**NOTICE OF A CHANGED APPLICATION**  
*Planning Act 2016 Section 52(1)*  
*Development Assessment Rules Section 25.1*

**Development Application for:** Reconfiguring a Lot – Code – Two (2) Lots into 342 Residential Lots, Three (3) Balance Lots and One (1) Drainage Lot  
**Location:** Lots 5-8 & 20-24 A341, Lot 279 AG3110 and Lot 280 AG3111 689 Toowoomba Cecil Plains Road, WELLCAMP QLD 4350  
**Property Description:** Lots 5-8 & 20-24 A341, Lot 279 AG3110 and Lot 280 AG3111

**RE:      RESPONSE TO FURTHER ADVICE**  
**SECTION 35 OF THE DEVELOPMENT ASSESSMENT RULES**  
**689 TOOWOOMBA CECIL PLAINS ROAD, WELLCAMP QLD 4350**

**Re: Development Application Further Advice (RAL/2022/4965)**

Figure 1 – Indicative driveway locations for Lot 256 and Lot 265 (in blue)

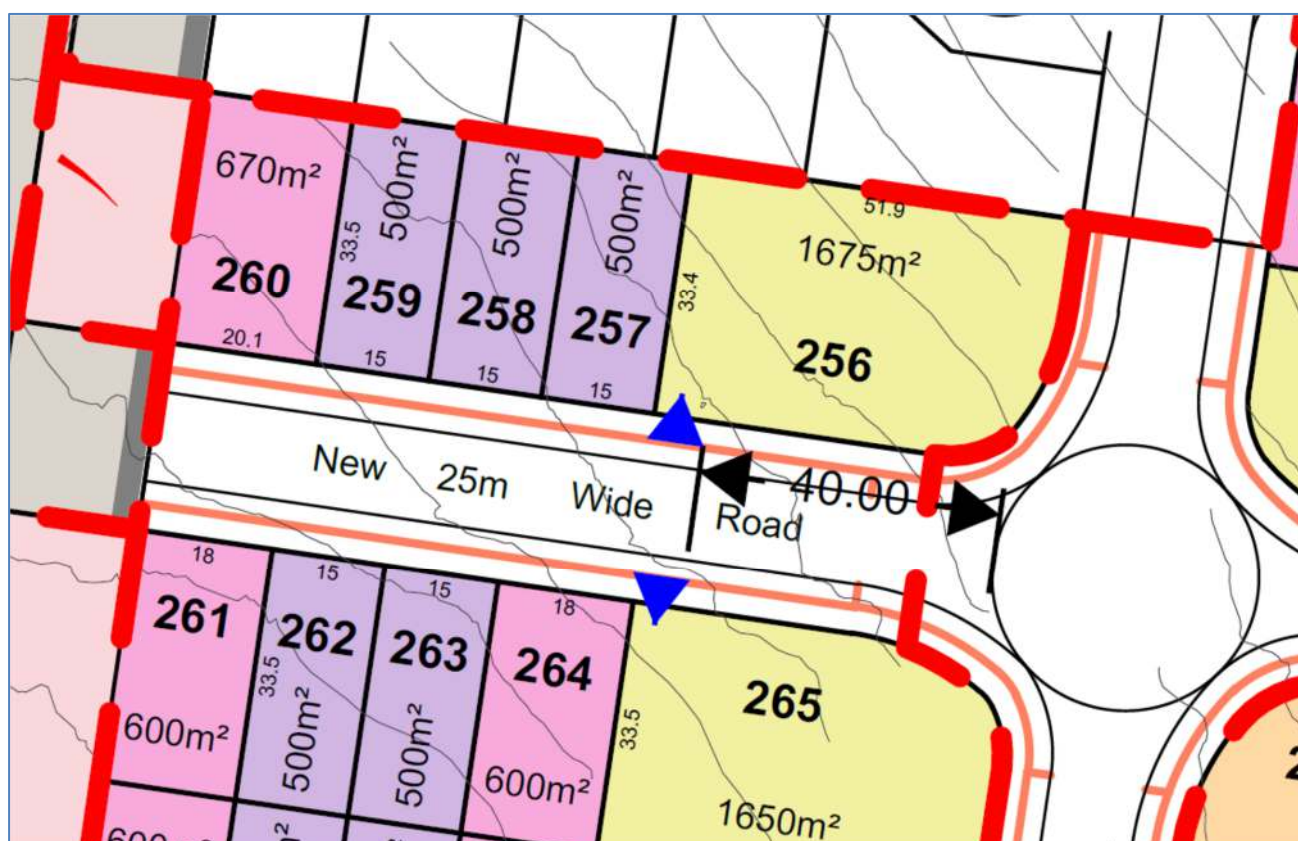
**1.2** Direct access to a distributor road is typically limited and not provided within 40m of an intersection. Council does not accept the response by Bitzios that multiple access points for the western block provided along the adjacent roads e.g., Toowoomba-Cecil Plains Road, Deuble Road and Devine Road will reduce the traffic volumes on Road 11 as shown on Plan C-R0201 to less than 3000vpd. Toowoomba-Cecil Plains Road is a state-controlled road and the TMR approach outlined in the Guide to Traffic Impact Assessment is that the traffic carrying function of state-controlled roads should be preserved and access to state-controlled roads should be minimised where safe and efficient access points can be provided by the local government road network. If there is no new access allowed to Toowoomba-Cecil Plains Road, then traffic accessing Toowoomba to and from the east will be attracted to Road 11 because this provides the most direct connection point. The distributor function of Road 2 is being compromised through the siting of lots as small as 500m<sup>2</sup> with narrow 15m frontages. These

Please amend the reconfiguration layout ensuring access points are at least 40m away from the intersection and reducing the number of properties with direct access to Road 2. Council will consider an approach that includes consolidated access points for adjacent properties and the provision of indented parking bays.

The proposed development has been amended to ensure that there are no future access driveways within 40m of the proposed intersection – refer to the revised plans in **Attachment A**. As illustrated in **Figure 1** below, the future access driveways for Lot 256 and 265 will be located further than 40m from the proposed intersection – which may also be conditioned by Council as part of the approval.

Figure 2 – Indicative temporary RCV turn around area (in red)

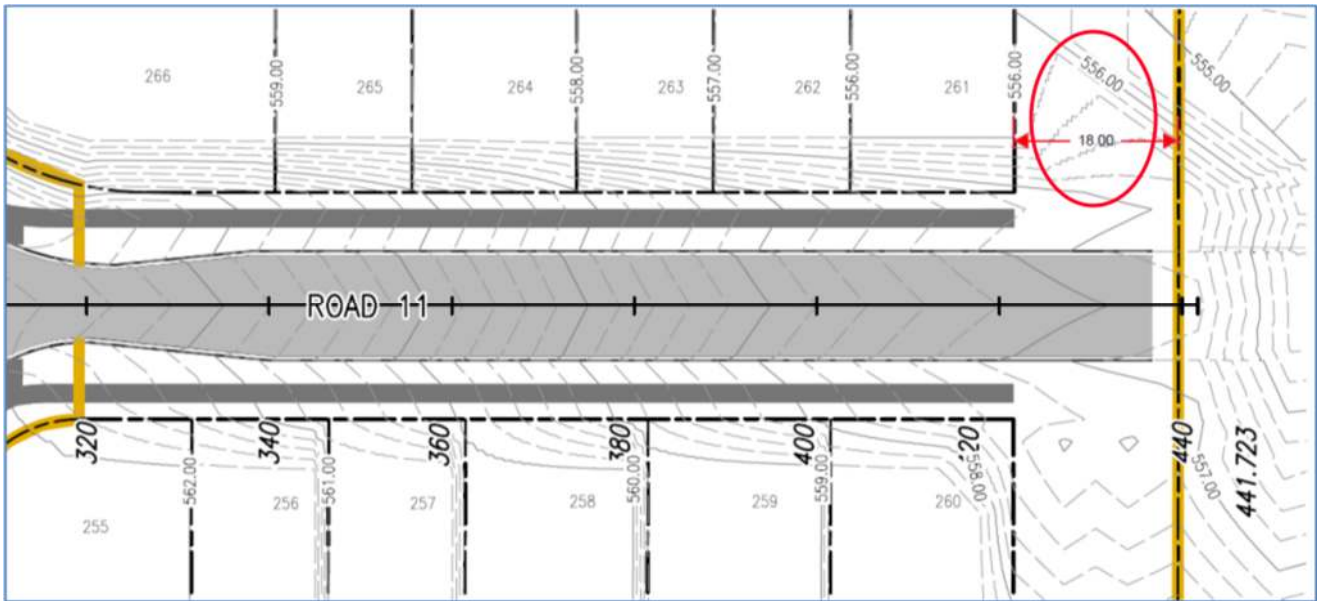
**5.1** A dimensioned turnaround area for a waste collection vehicle has not been demonstrated at the end of Road 11.

Please provide a dimensioned waste collection vehicle turnaround area at the end of Road 11 on amended plans, including a swept path diagram. Please refer as required, to Council's Technical Guidelines for New Developments Waste Storage and Collection Requirements for assistance.

There is an ~18m wide area of future road reserve at the end of Road 11 (next to Lot 261) which is able to comfortably accommodate any required temporary RCV turn around (refer to **Figure 2** below). This will be designed as part of any future OPW application and can be conditioned by Council to be provided.

GAINSBOROUGH LODGE  
OVERALL PROPOSAL PLAN

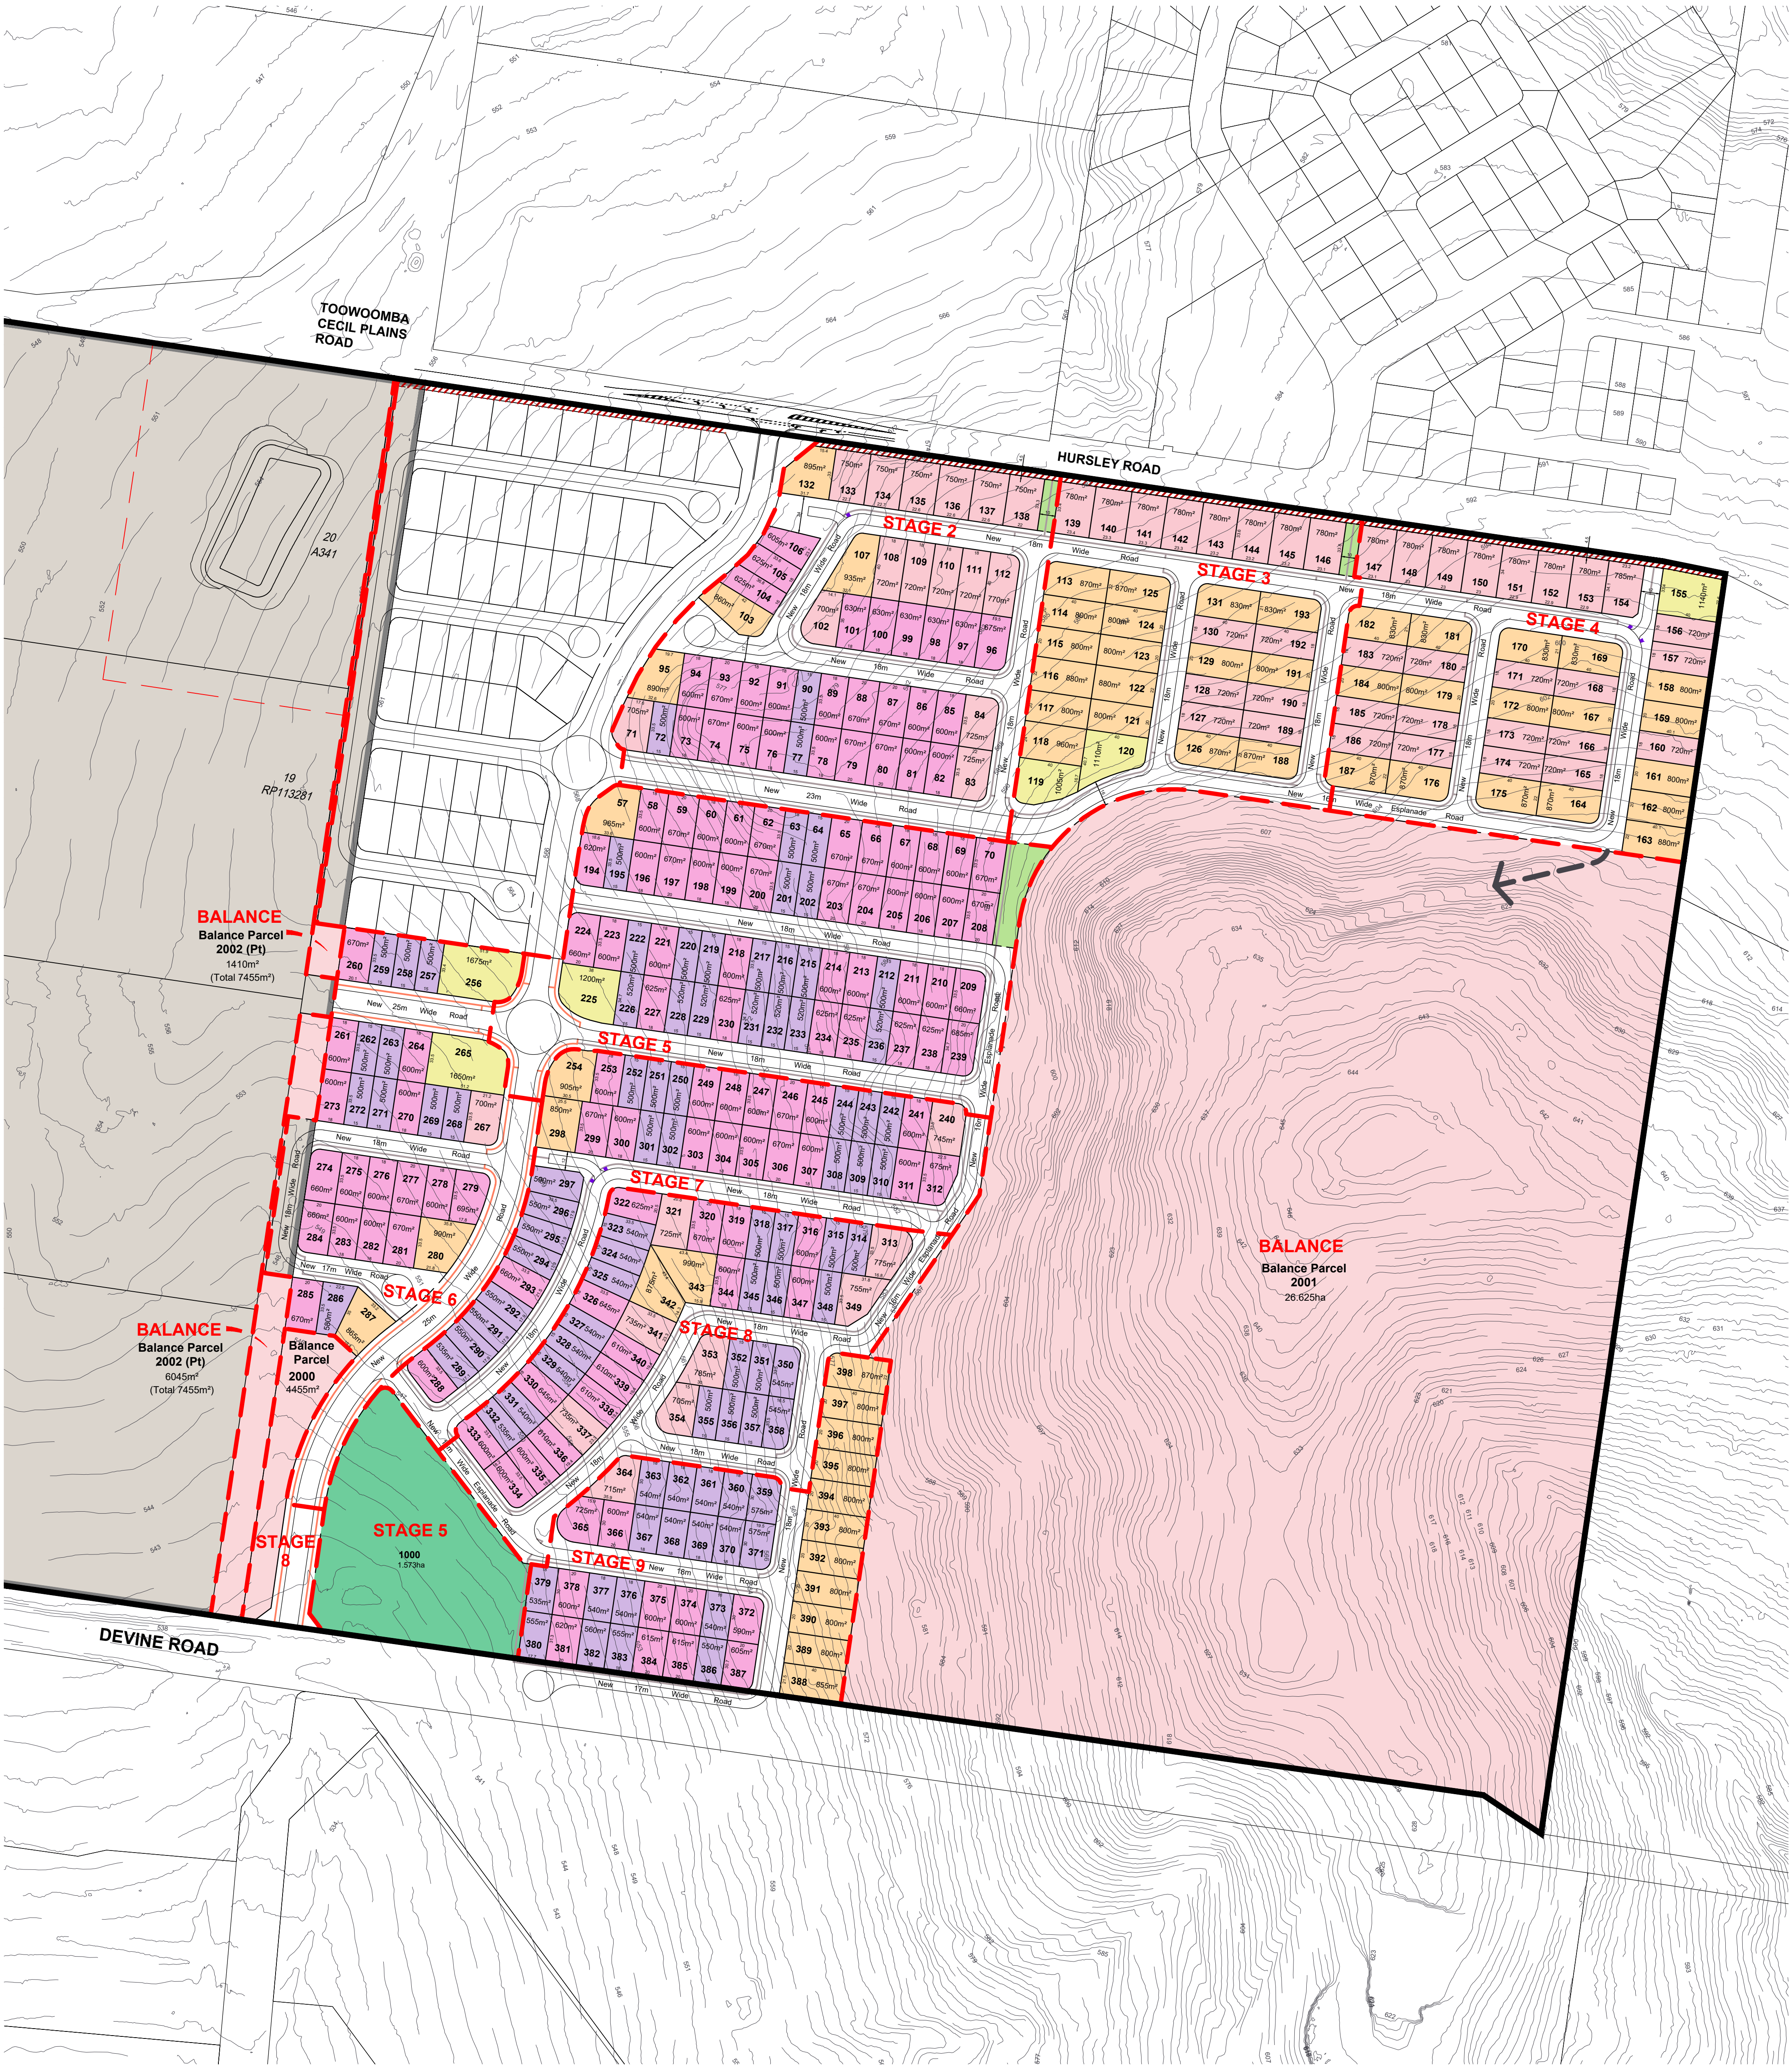
**1.3** Proposed lots 92 to 95 gain street access via a common driveway within a 12m road reserve. Lot 103 may also use this driveway to gain rear lot access. This type of street is not a road hierarchy category supported within PSP No 2 Engineering Standards Roads and Drainage Infrastructure. Council does not support this number of blocks being serviced by a driveway some 70m long. Please amend the reconfiguration layout reducing the number of lots requiring access to the street via a driveway. This could include provision of a cul-de-sac.

1.3	<p><b>Issue:</b></p> <p>Proposed lots 92 to 95 gain street access via a common driveway within a 12m road reserve. Lot 103 may also use this driveway to gain rear lot access. This type of street is not a road hierarchy category supported within PSP No 2 Engineering Standards Roads and Drainage Infrastructure. Council does not support this number of blocks being serviced by a driveway some 70m long.</p> <p><b>Information Required:</b></p>

As identified above, the proposed 12m wide access road between Lot 103 and Lots 92 – 95 has been removed and replaced with a 17m wide cul-de-sac. Furthermore, Lots 103 – 106 have been reconfigured slightly to accommodate the new cul-de-sac – refer to the revised plans in **Attachment A**.

Please amend the reconfiguration layout reducing the number of lots requiring access to the street via a driveway. This could include provision of a cul-de-sac.
	<b>Response:</b> An updated Plan of Development has been provided by RPS which provides provision of a culdesac at the subject location. Engineering details will be provided with future Operational Works Applications.
